REQUEST FOR MINOR MODIFICATION

RE: Evergreen Commons Minor Modification / Plan Modifications and HOA Change

The Applicant now comes before the Board and requests the Board approve changes to the landscape plan, the stormwater design and the Homeowner's Association Document as follows:

PORT PLACE
LANDSCAPE PLAN

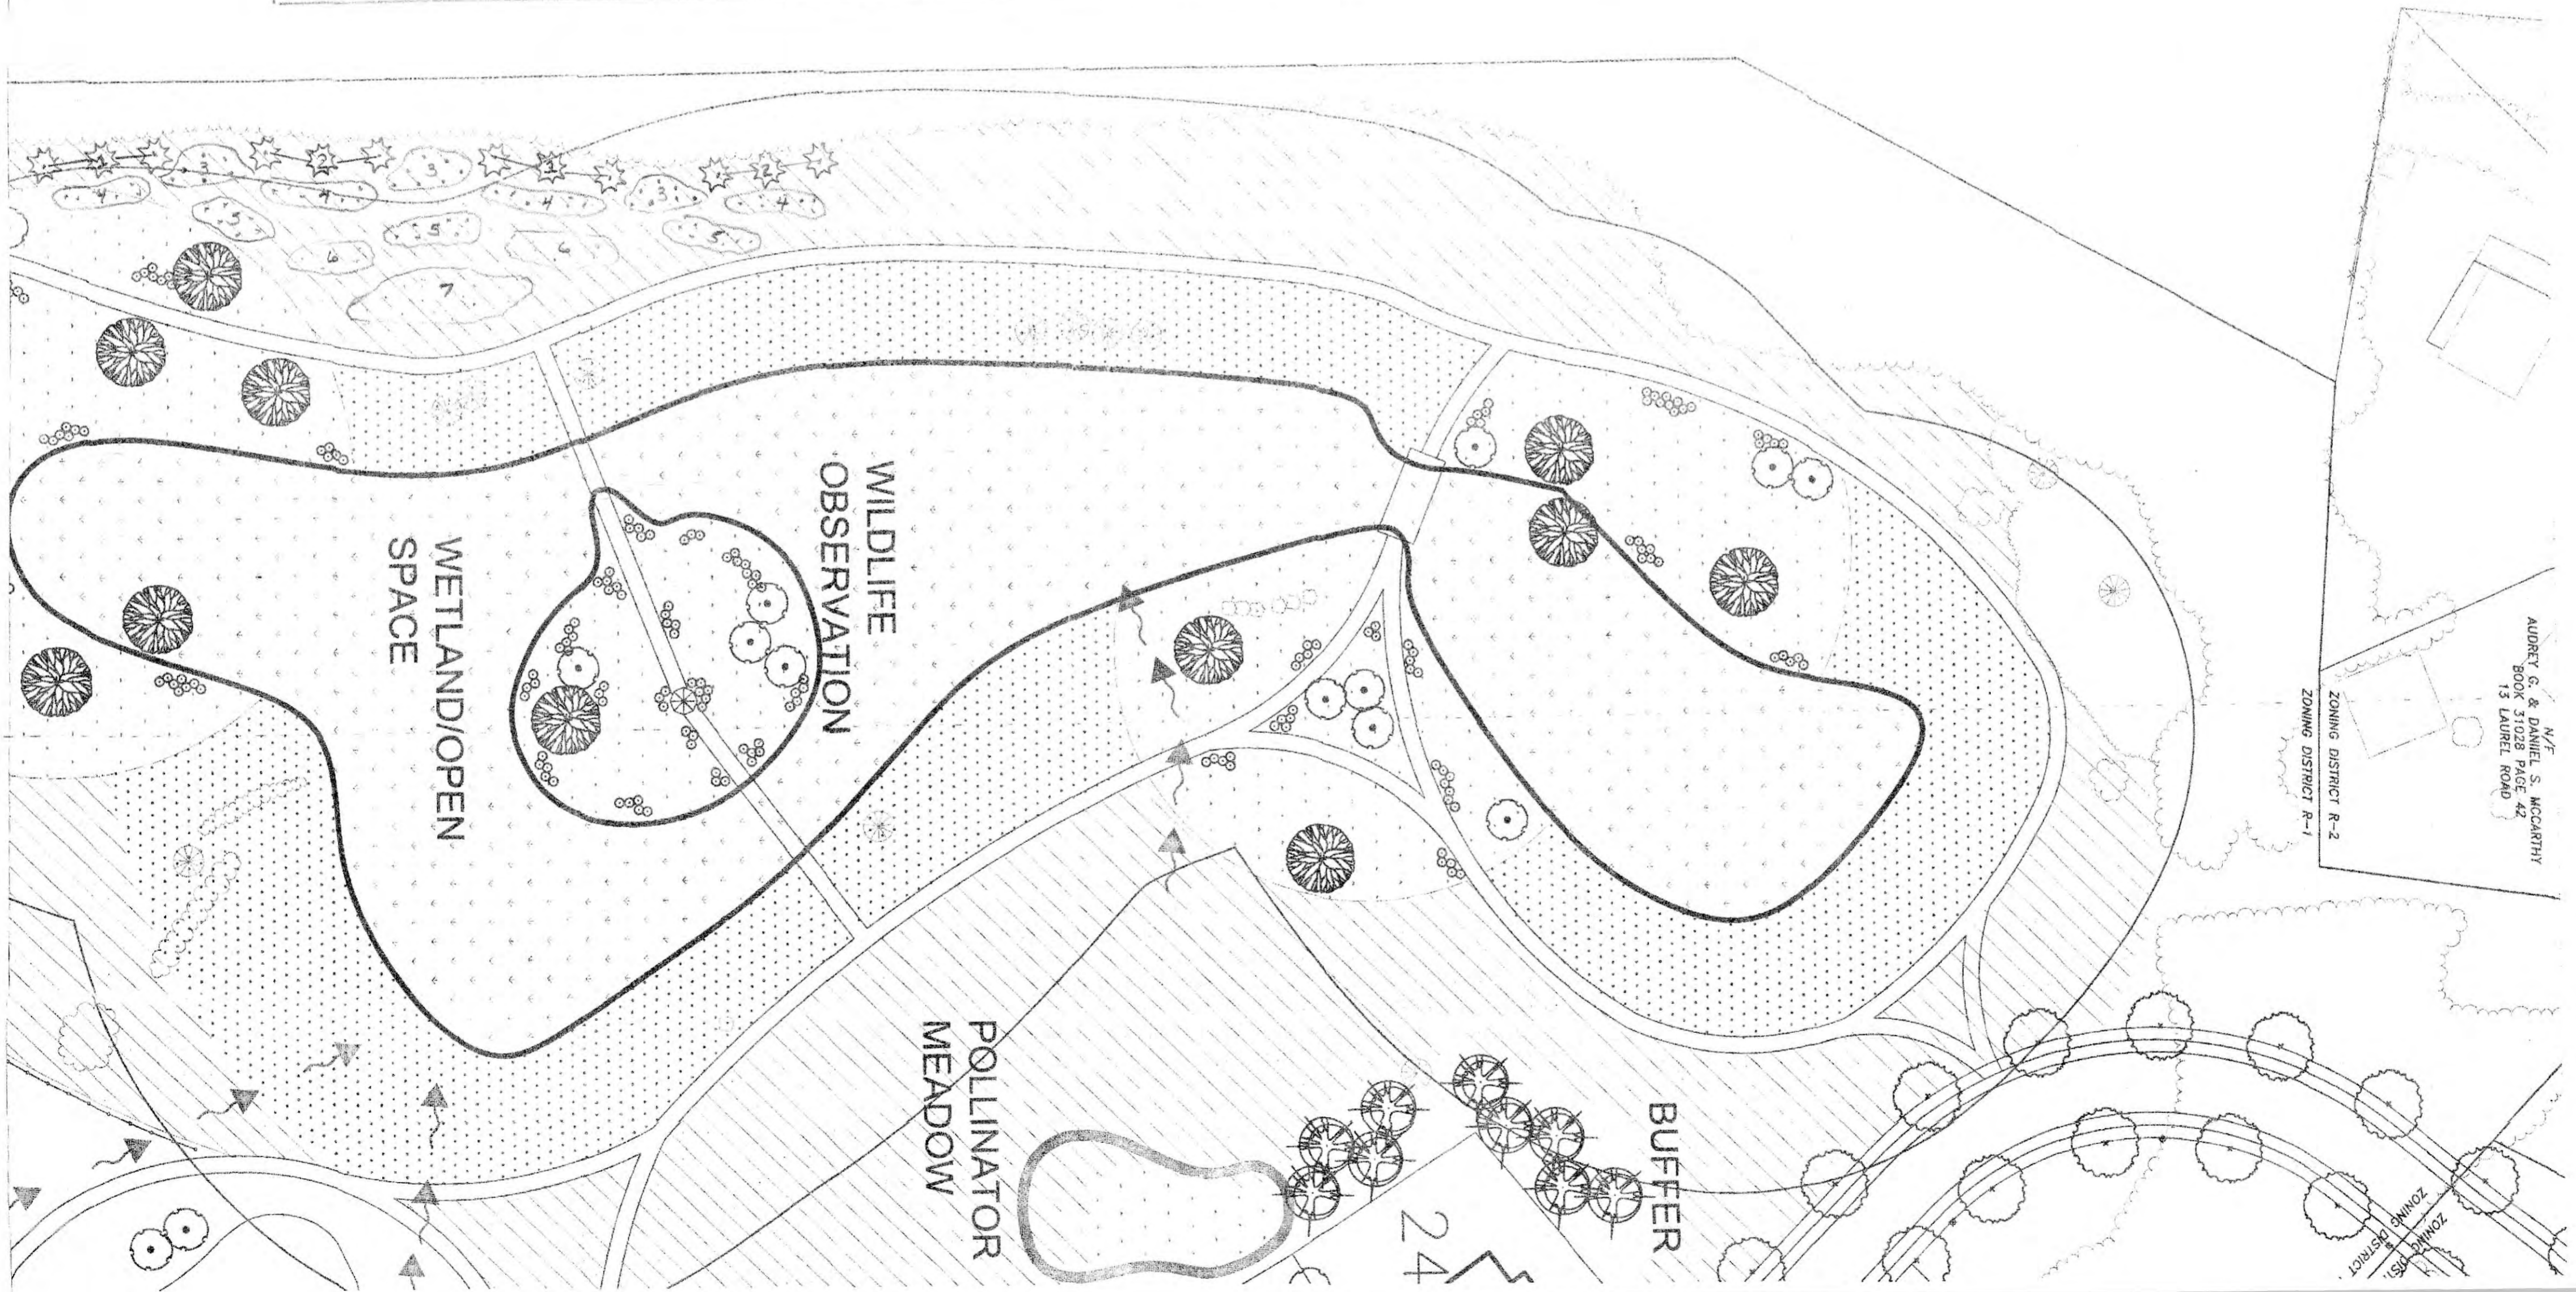
- c. a new category for the meadow area south and west of the IVW “Transitional Meadow” which includes shrub and tree plantings that better fit within these areas that abut wooded areas. We will be planting approximately 400 native shrubs and saplings in this new area to transition from the open meadow areas to the wooded areas and allow for better habitat in these shadier areas near the existing wood line

Attached you will find two updated plan sheets, a hand mark up of sheet L-1 showing the street tree changes, and two hand mark ups of portions of the landscape plans for the Transitional Meadow Area. Additionally, we have updated sheet L-0. The copy of L-0 attached has been colored in to work with the maintenance chart. Additionally, I have attached an updated maintenance chart to be clear that mowing in all areas must go around shrubs and trees for clarity. The Transitional Meadow will be maintained at the same time as the Pollinator meadow.

1. 6 PINUS STROBUS / WHITE PINE 2/3'
2. 6 JUNIPERUS VIRGINIANA / EASTERN RED CEDAR 2/3'
3. 28 CORNUS RACEMOSA / GRAY DOGWOOD 18/24"
4. 36 CORNUS SERICEA / RED OSIER DOGWOOD 18/24"
5. 27 ILEX VERTICILLATA / WINTER BERRY 18/24"
6. 20 CEANOTHUS AMERICANUS / NEW JERSEY TEA 18/24"
7. 30 COMPTONIA PEREGRINA / SWEET FERN 18/24"

SITE PLAN DRAINAGE UPDATE
 S.SAWYER/DCI
 MARCH 31, 2021

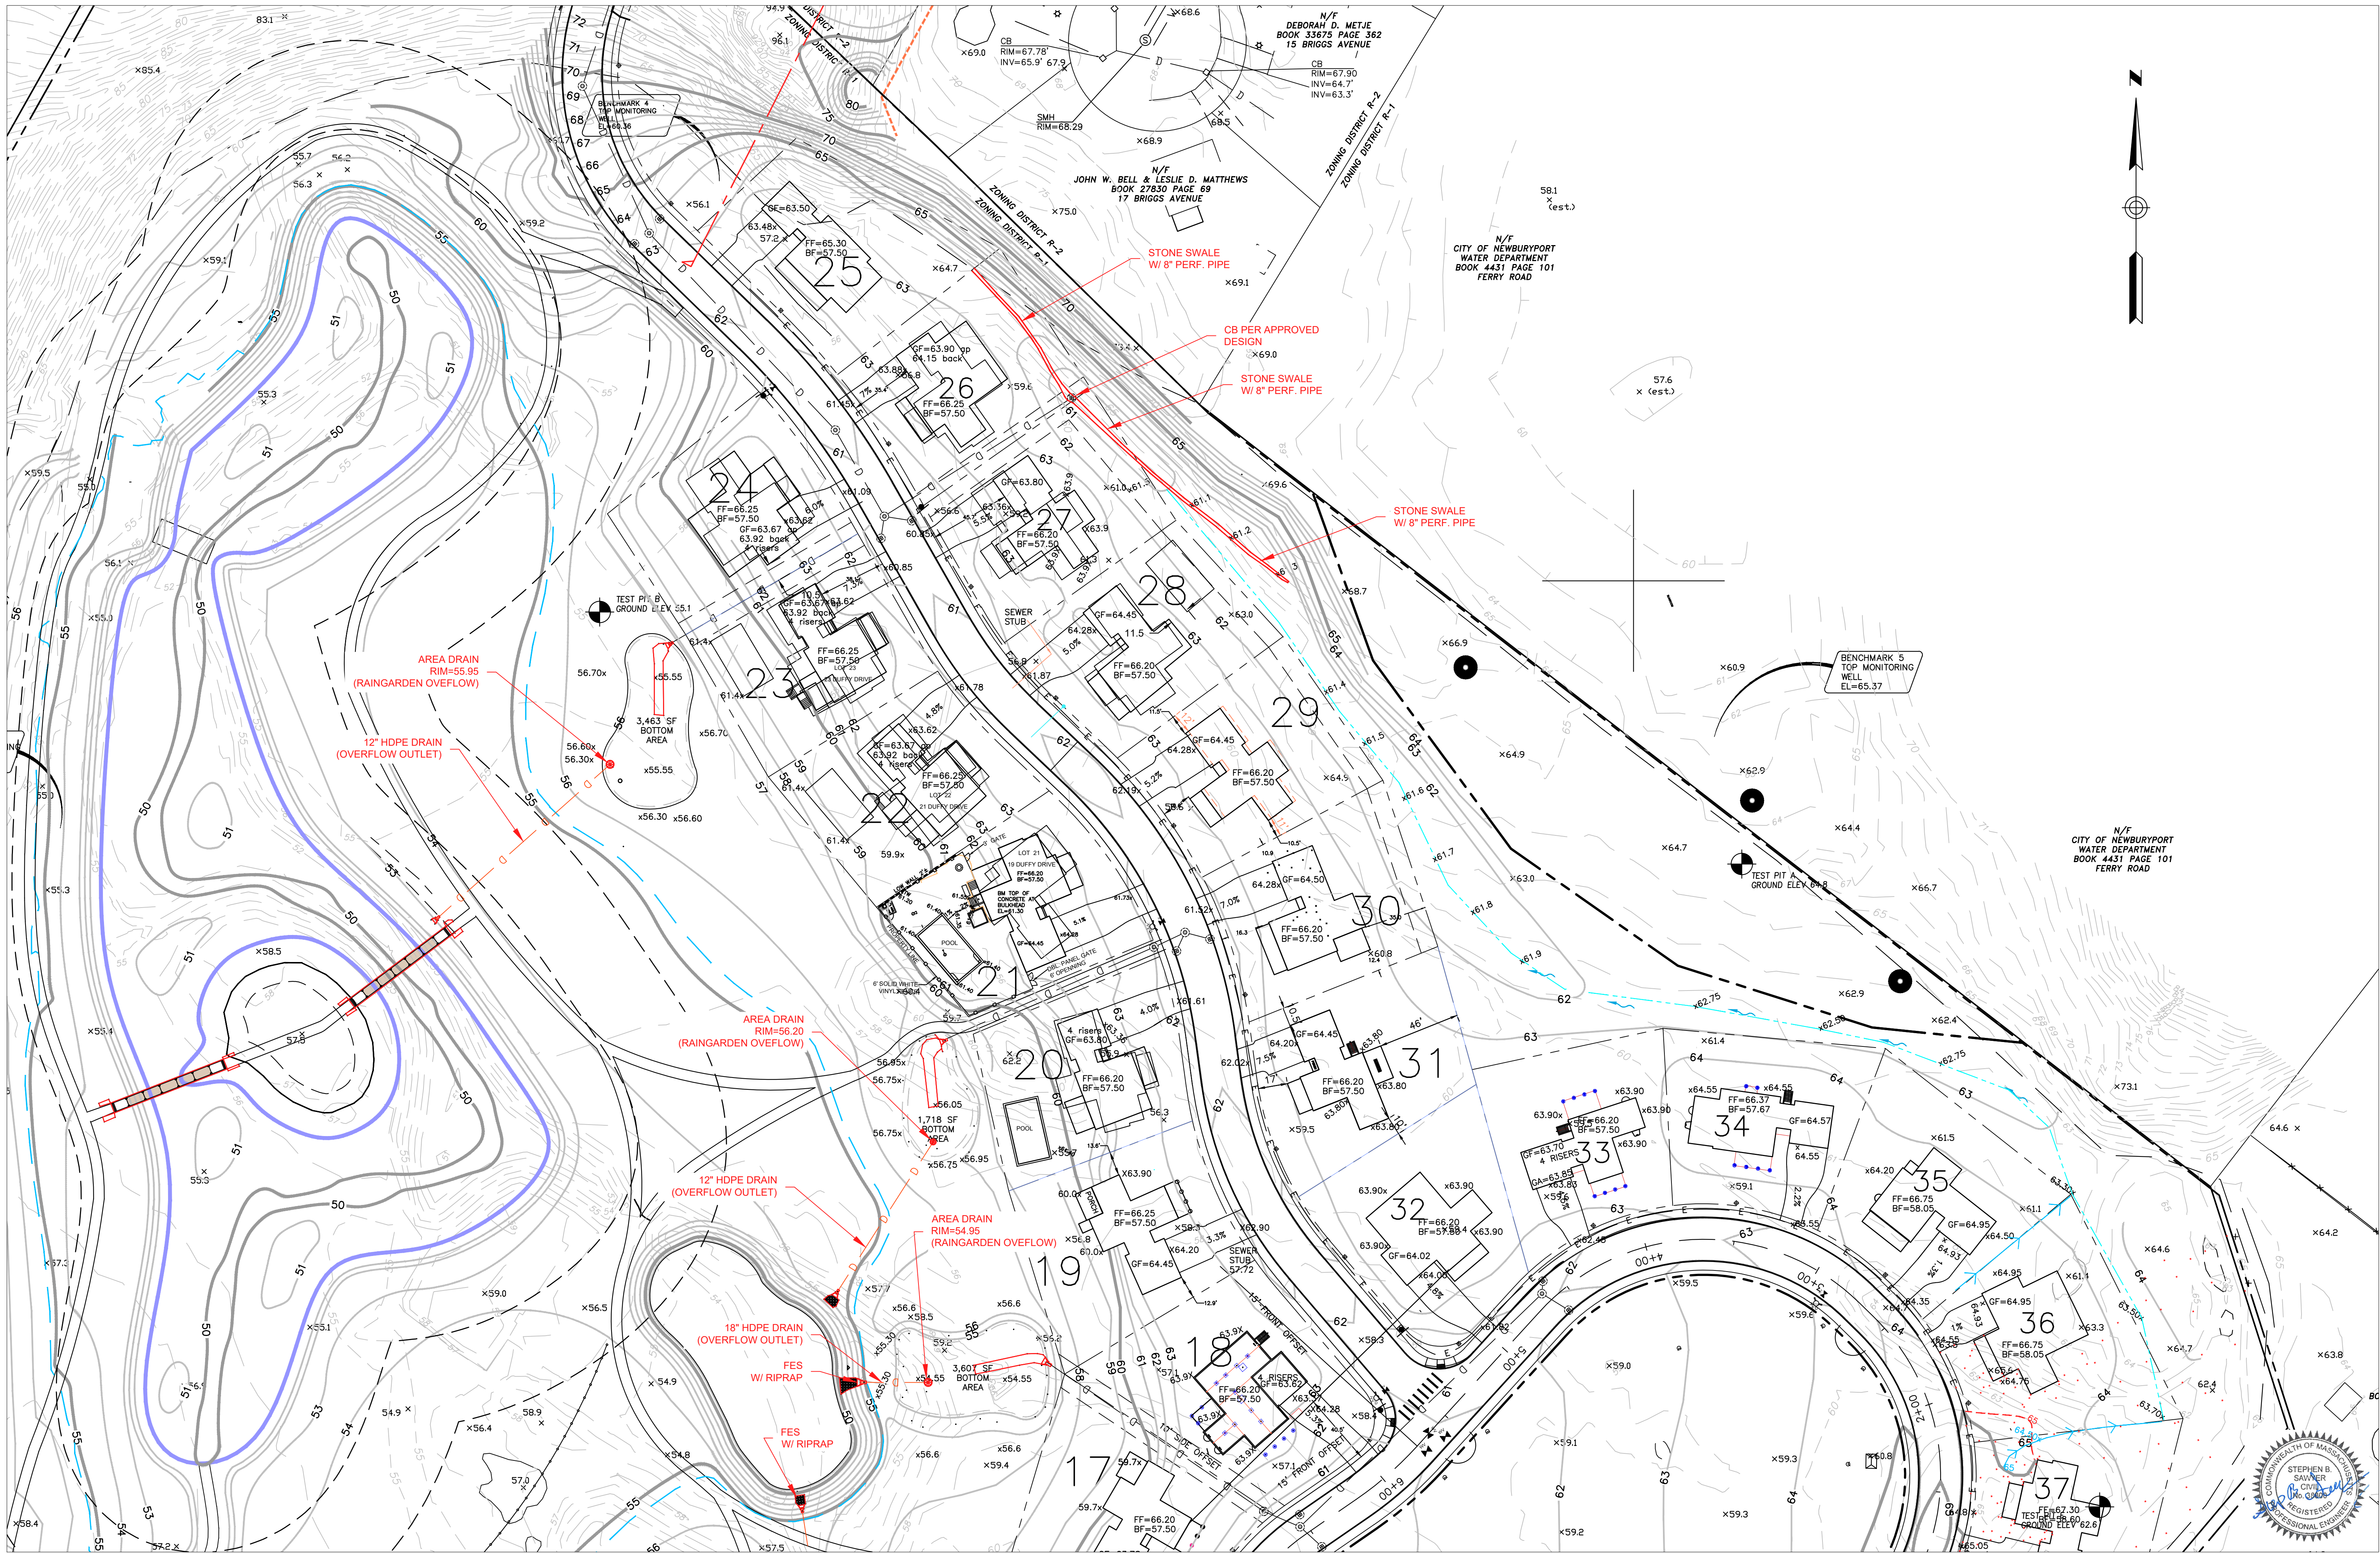
- 1. Stormwater system changes made in coordination with the City Engineer, including:
 - a. The 3 drywells and drain located behind lots 26 - 31 have been removed. We have provided a stone swale and perforated pipe to direct runoff to the catch basin located behind lots 26/27. This catch basin was included in the approved design with the 8" pipe directing flow to Rain Garden F (this change was made at the direction of the City Engineer, Jon-Eric White.)

- b. We have provided piped overflow from Rain Gardens C, D, E & F. This was done due to erosion issues from surface overflow running overland. These changes did not change the designed water quality volume with the overflow rims set a minimum of 9 inches above the bottom of the rain gardens as in the approved design. These outlet changes were reviewed and approved by City Engineer Jon-Eric White.

- c. A drywell with outlet pipe was installed behind lot 5 along with two area drains behind lots 6-7. This was done due to flat area where some puddles remained after rain events. This did not change any of the stormwater design intent with the drainage from this area directed to rain garden B in the original design and through the provided area drain and piping with this change.

NOTE MAINTAIN TRANSITIONAL MEADOW AREA AT SAME TIME AS POLLINATOR MEADOW. NOTE IN ALL AREAS MOW AROUND SHRUBS AND TREES. REVISED 4-16-21
